City of Seward, NE

CONSIDERATION OF AN ORDINANCE APPROVING THE FINAL PLAT FOR CNG FIRST ADDITION (Second Reading) - John Hughes

CNG Runoff

Site Drainage Plan
C1.3

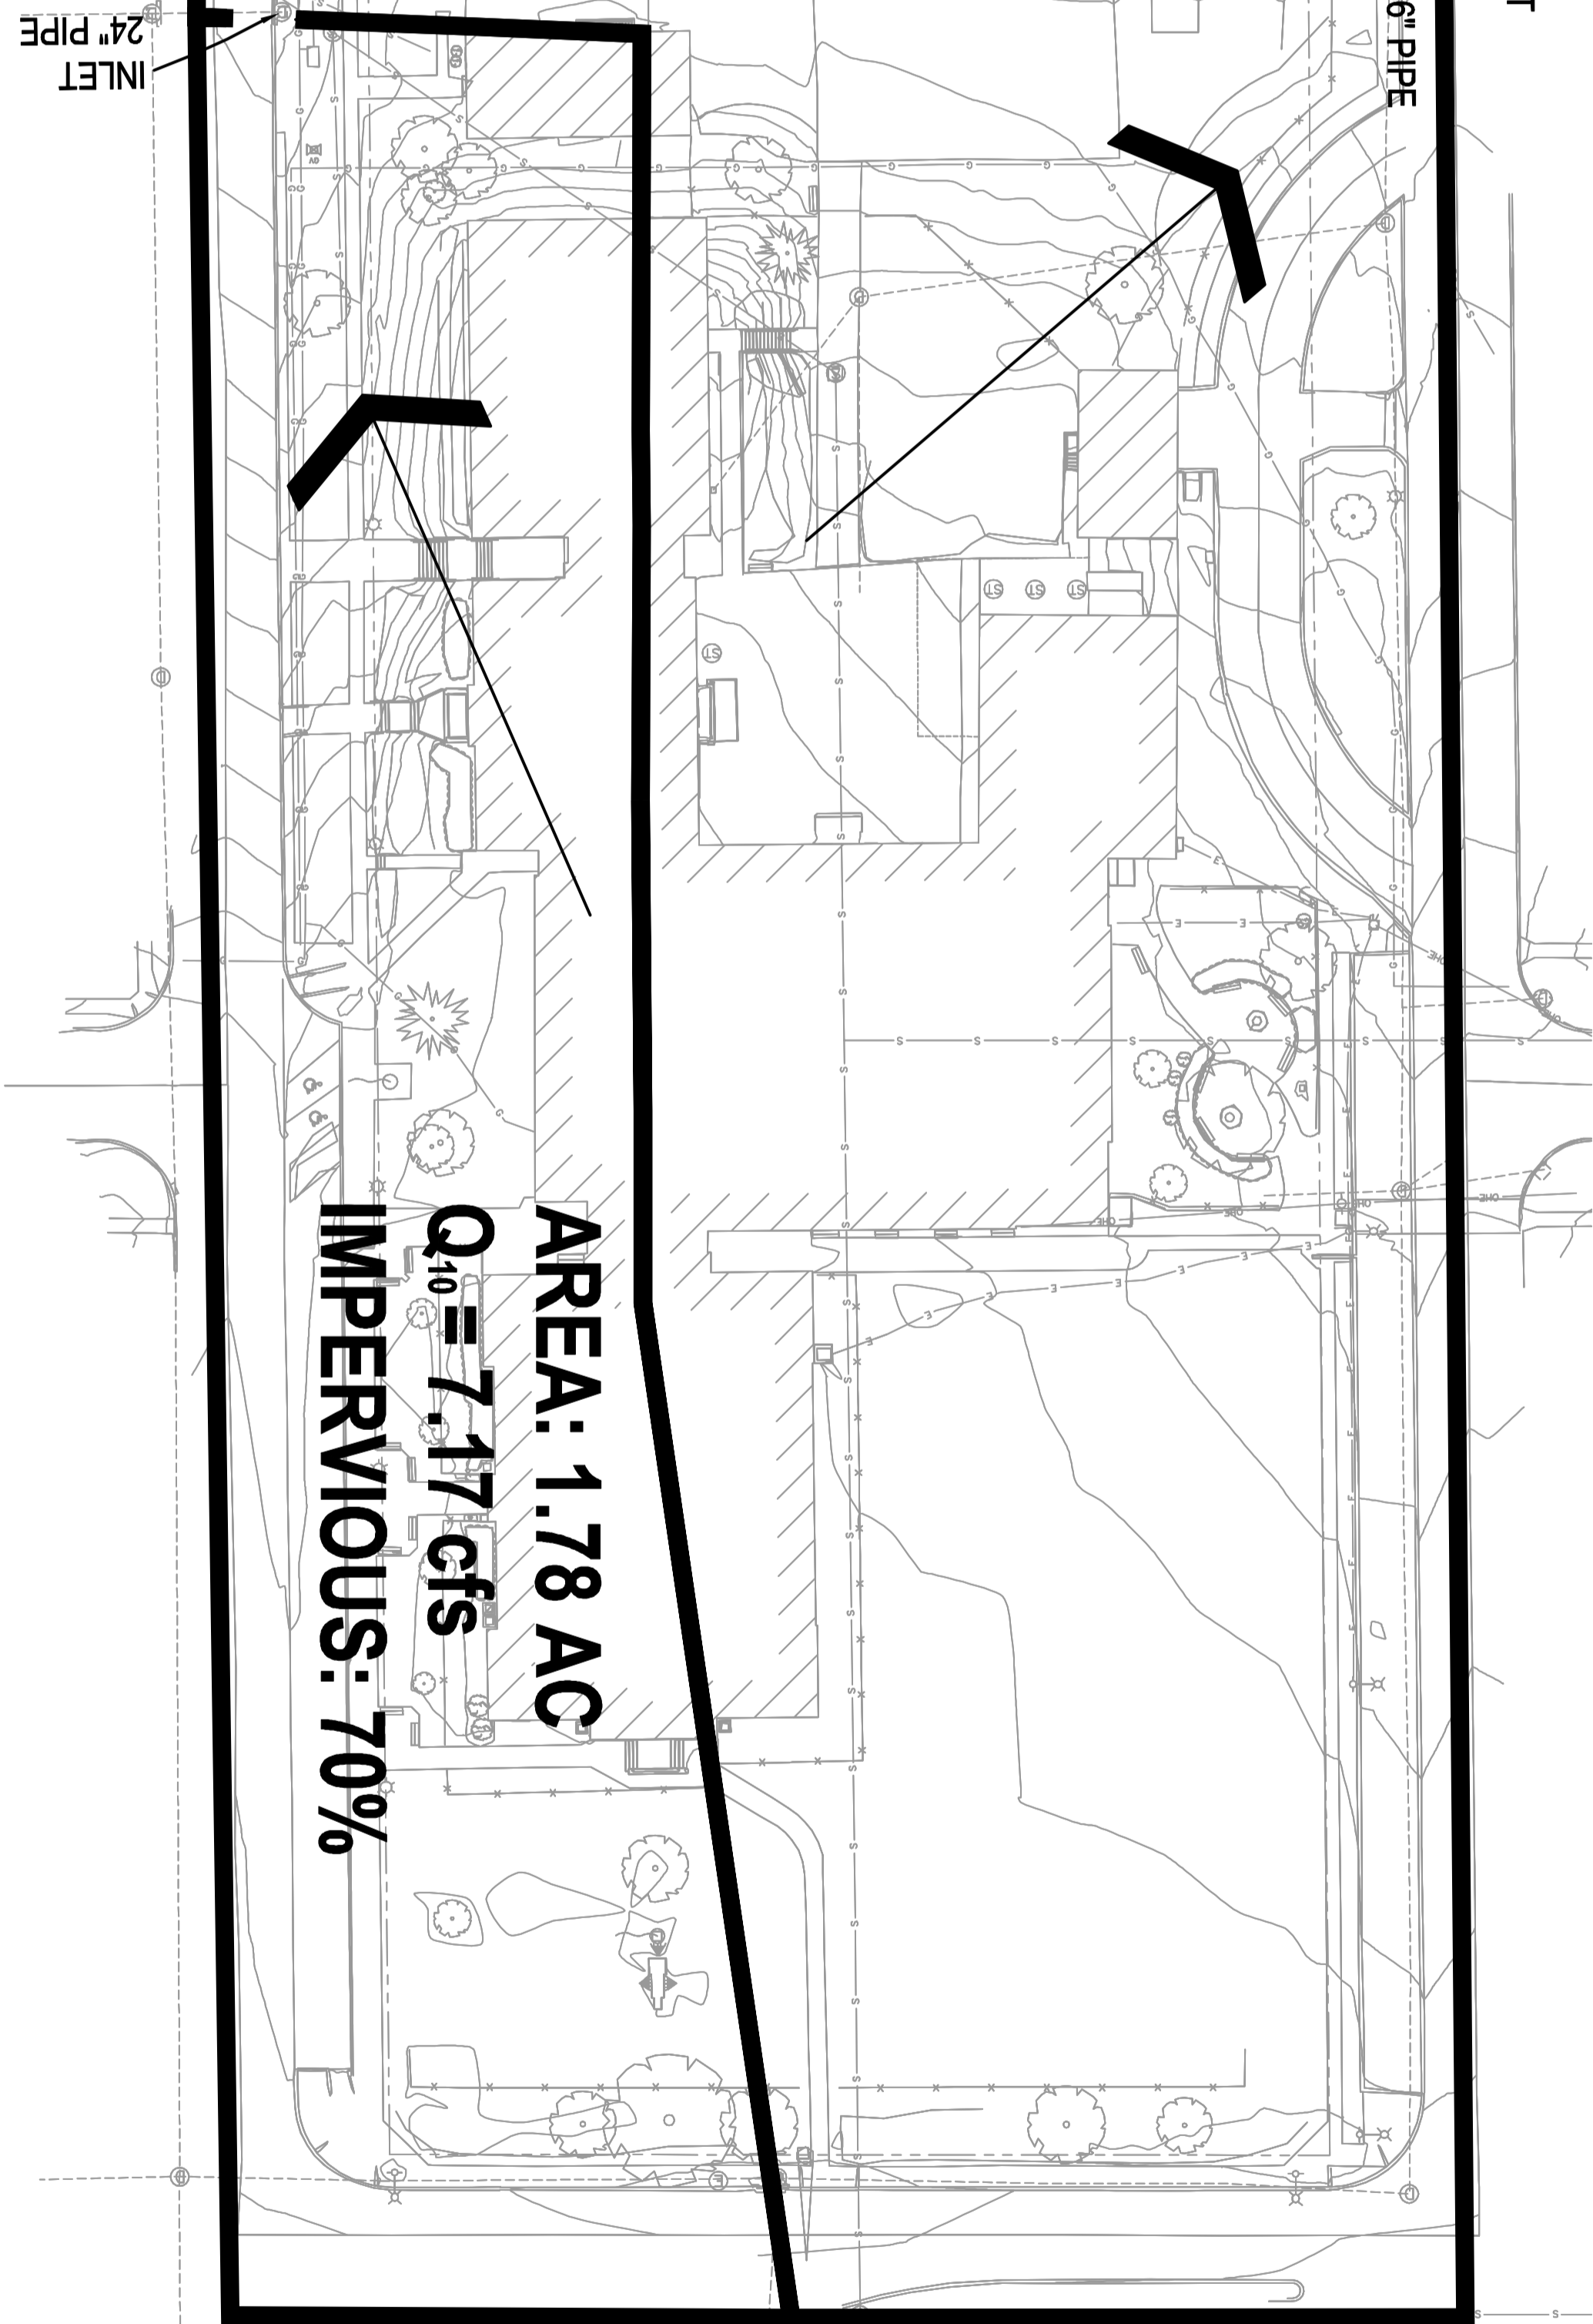
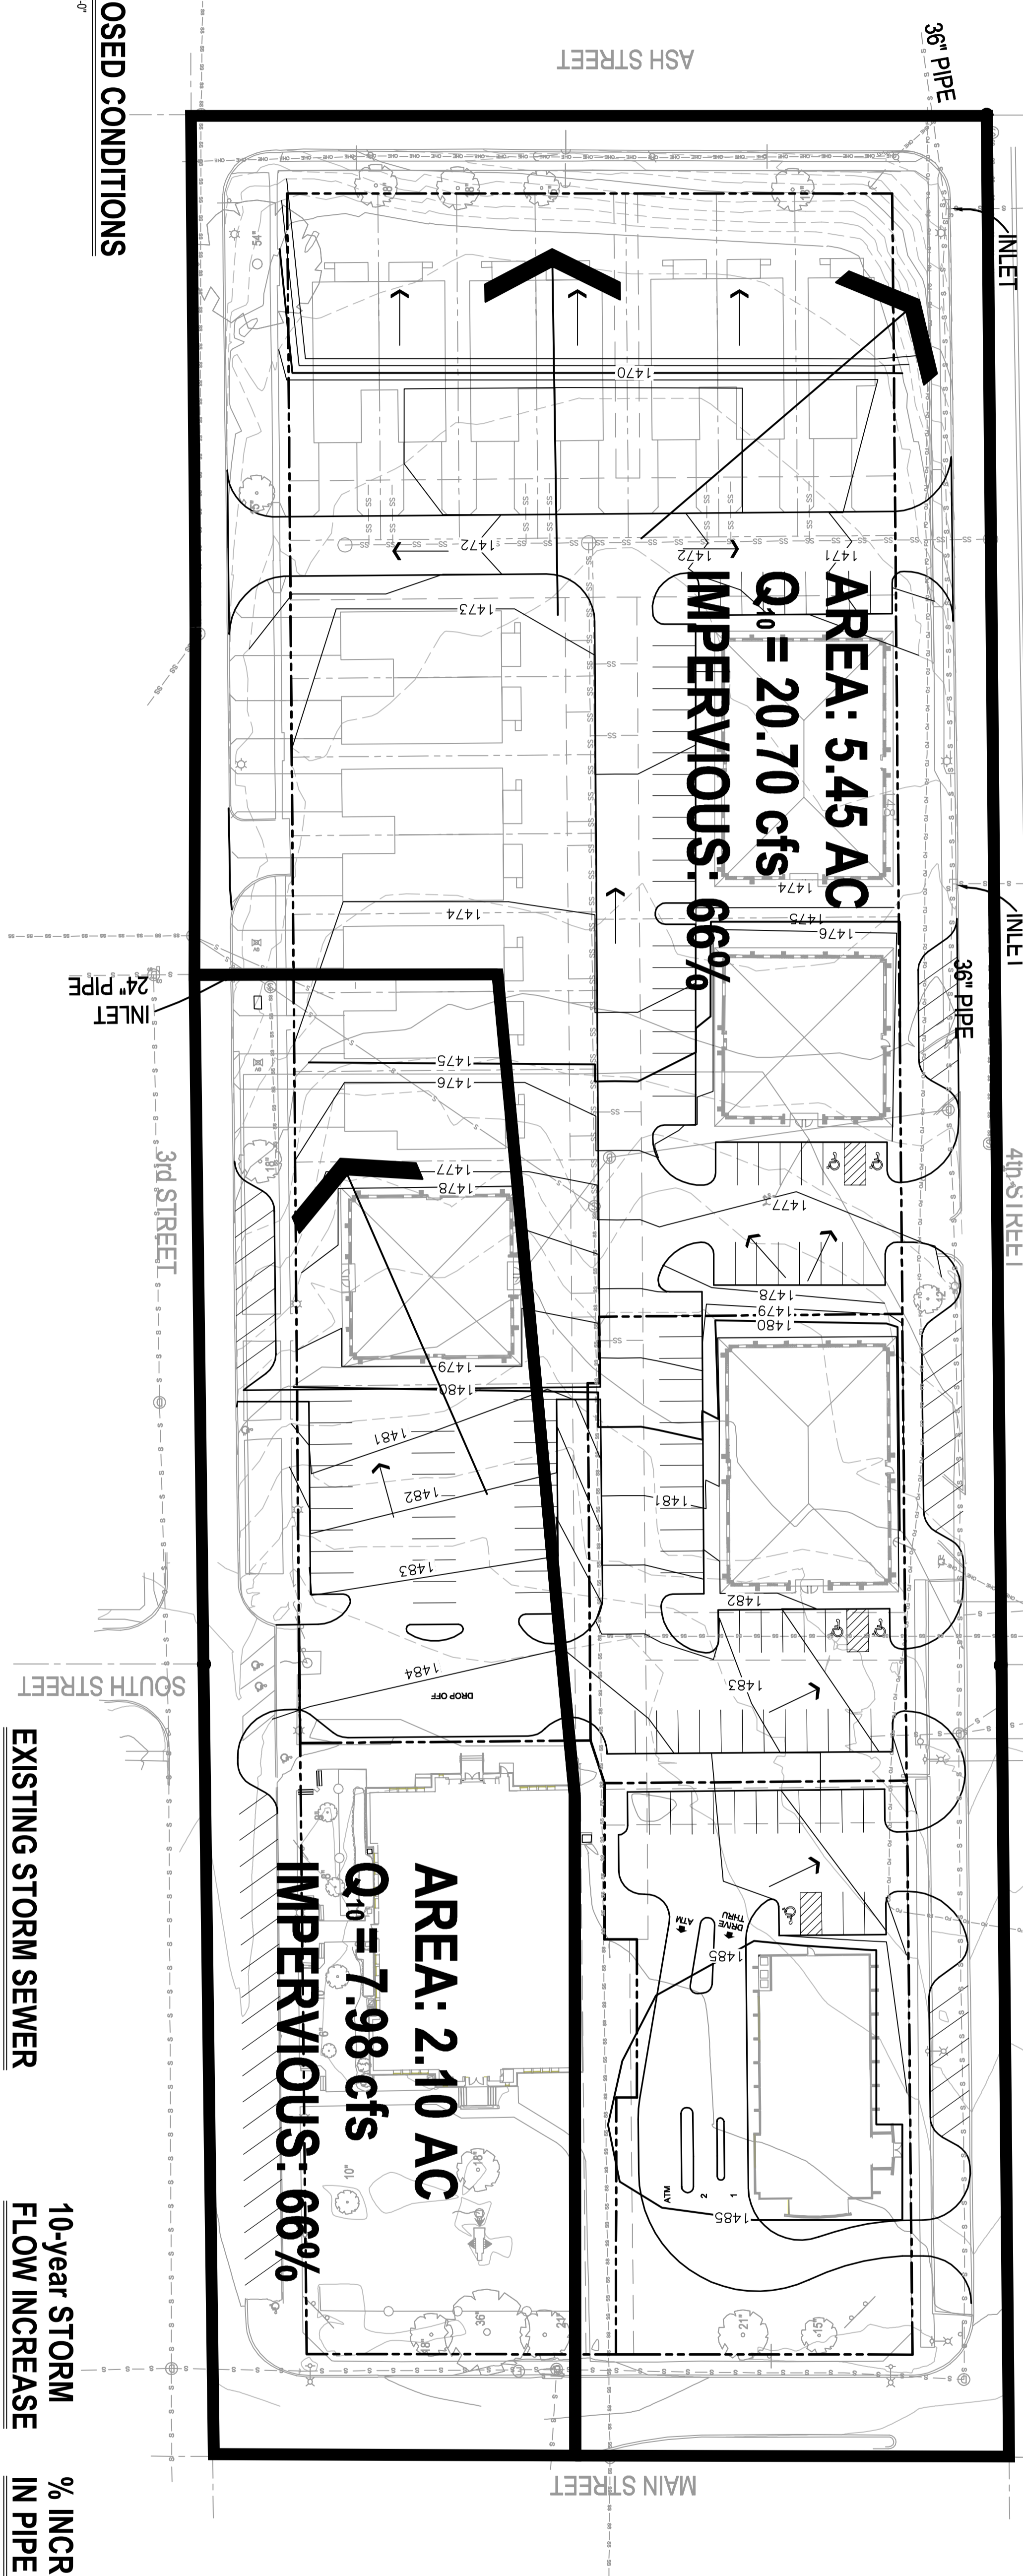
In regards to the drainage runoff on the CNG properties, you will find an enclosed drawing of the site, that makes reference to the amounts of runoff in both the predevelopment stage as it was when the middle school was located there, and the bottom drawing indicates the runoff in a post development condition. Each drawing is broken into two locations, following the direction of flow to the storm sewer pick up points. You will note that there is a 36 inch diameter pipe on the west side along 4th Street, that will carry water off the site and into the storm system in that area, and a 24 inch diameter pipe on the east side of the property along 3rd Street that will pick up the water and move it to the storm system.

The design capacity of the 36 inch pipe will flow 117.62 cubic feet of water per second under a fully loaded condition, and was running at 3.11 percent capacity during a 10 year storm event under the conditions present when the school was in existence. The design capacity of the 24 inch pipe will flow 58.16 cubic feet of water per second under a fully loaded condition, and was running at 3.11 percent capacity during a 10 year storm event under the conditions present when the school was in existence.

In the drawing that depicts the site under post development stage you will note that the increase of the 36 inch pipe equates out to 10.24 which adds up to a combined cubic feet per second to 20.70. This leaves the pipe capacity under a loaded condition of a ten year storm event well under 25 percent. The 24 inch pipe will see an increase of .81 cubic feet per second with a combined rate of 7.98. Again this addition

Therefore, it would appear that the runoff is within the parameters of being dispersed into the system without creating any adverse conditions to the neighborhood.
